APPLICATION NO.	FILING DATE	FIRST NAMED INVENTOR	ATTORNEY DOCKET NO.	CONFIRMATION NO.
10/600,112	06/20/2003	Stephan Karl Barsun	200209739-1	7760
22879	7590	06/28/2005	EXAMINER	
HEWLETT PACKARD COMPANY P O BOX 272400, 3404 E. HARMONY ROAD INTELLECTUAL PROPERTY ADMINISTRATION FORT COLLINS, CO 80527-2400			DUONG, THO V	
			ART UNIT	PAPER NUMBER
			3743

Office Action Summary	Application No. 10/600,112	Applicant(s) BARSUN ET AL.	
	Examiner Tho v. Duong	Art Unit 3743

DETAILED ACTION

Figure B: the modified figure corresponds to figure 2 with curved fins shown

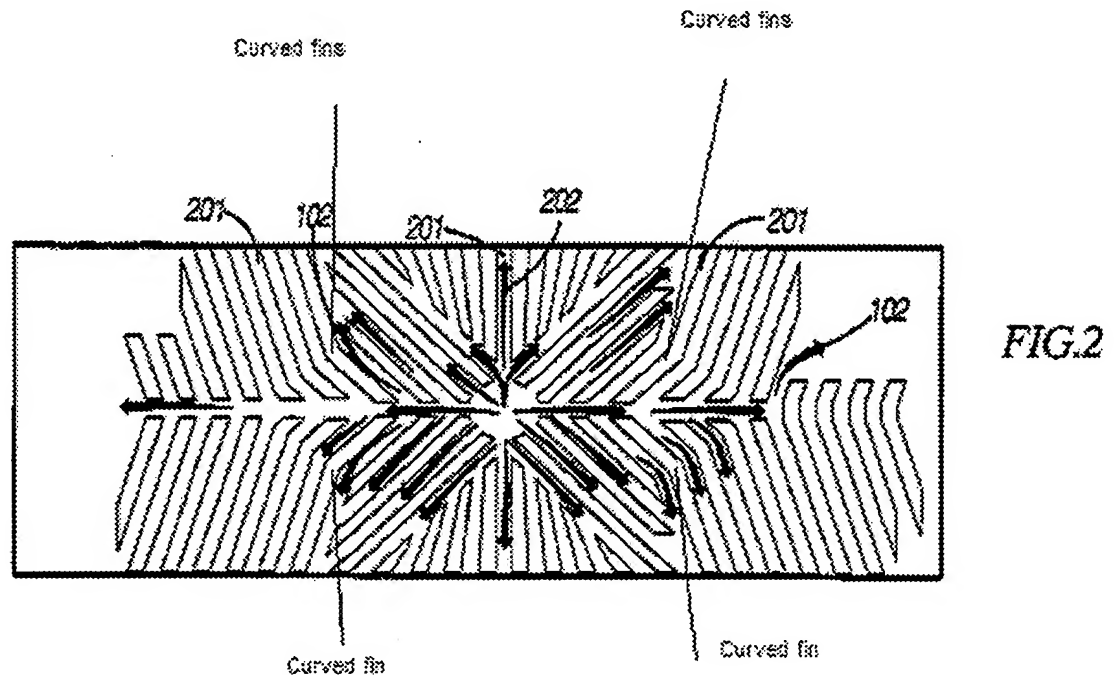
Claims 1-5,8-11,13,14,16 and 18-19 are rejected under 35 U.S.C. 102(b) as being anticipated by Wildmayer (US 5,582,240). Wildmayer discloses (figures 1 and 2) a device for removing heat from an electronic component, comprising a heat sink (200) adapted to couple to the electronic component and conduct heat therefrom; a plurality of fins being integral part of the heat sink to transfer heat into a cooling air, wherein the fins are oriented at an obtuse angle with respect to a plurality of flow streams (102,201) across the fins and wherein each flow stream of the plurality follows a unique direction. Wildmayer further discloses (figure 2) that the space between most of the fins is substantially even and the flow stream is following in all 4

perpendicular directions. Regarding claims 2, 9, 13 and 18, Wildmayer discloses (figure B as bellow) the small angle of curved fins is to gradually change the direction of the airflow.

Figure A: The modified figure corresponds to figure 4 with flow of stream air shown.

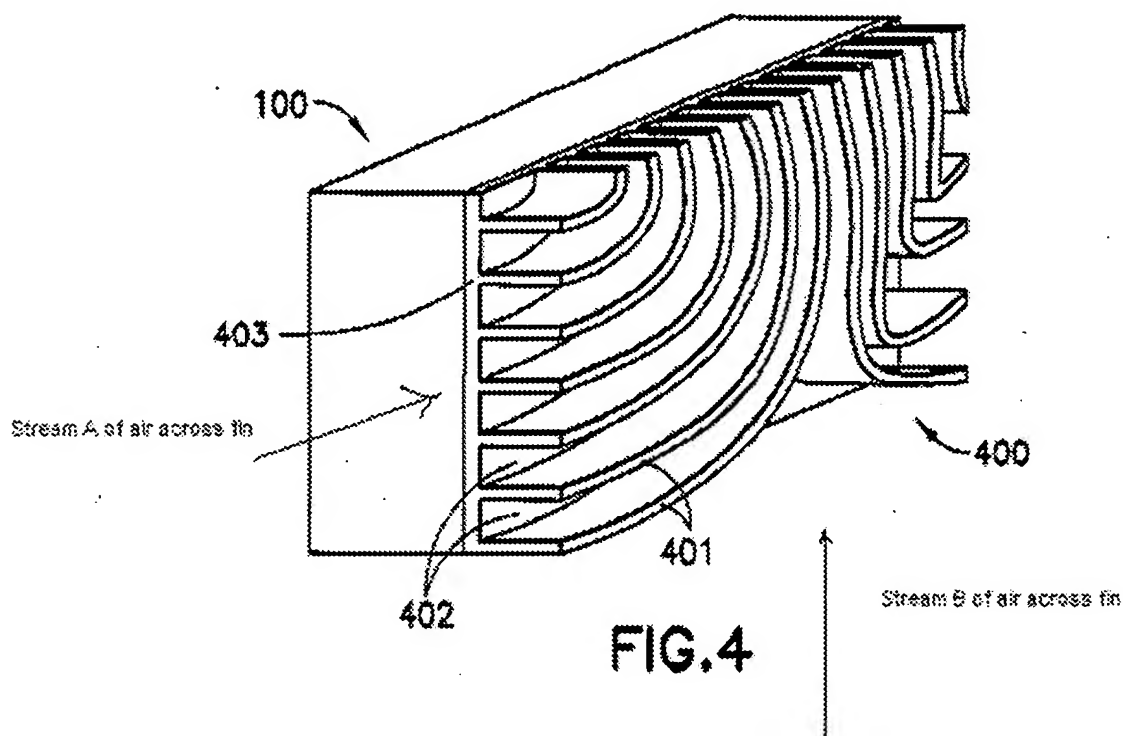
Claims 1-5,8-11,13,14,16 and 18-19 are rejected under 35 U.S.C. 102(b) as anticipated by or, in the alternative, under 35 U.S.C. 103(a) as obvious over Suntio (US 6,313,399). Suntio discloses (figures 3, 4 and figure A as follow) a device for removing heat from an electronic component (100), comprising a heat sink (300,400) adapted to couple to the electronic component and conduct heat therefrom; a plurality of curved fins (401) being integral part of the heat sink to transfer heat into a cooling air, wherein the fins (401) are oriented at an obtuse angle with respect to a plurality of flow streams across the fins and wherein each flow stream of the plurality follows a unique direction in channels (402) in a gradual change of direction. Suntio further discloses (column 2, lines 51-56) that the wide gap at the lower edge and/or side of the heat sink suck lot of air into the device. Since the lower edge and the side edge are orthogonal to each other, it would have been obvious to one of having ordinary skill in the art to see that the flow streams approaching each edge is substantially orthogonal to each other. As illustrated in figure A, the fluid streams (A) and (B) are oriented substantially orthogonal to each other. Regarding claims 1, 9 and 14, Suntio does not disclose that the space (402) is even through out

the flow channels but the space (402) between most of the fin (401) is substantially even at one side of the edge.
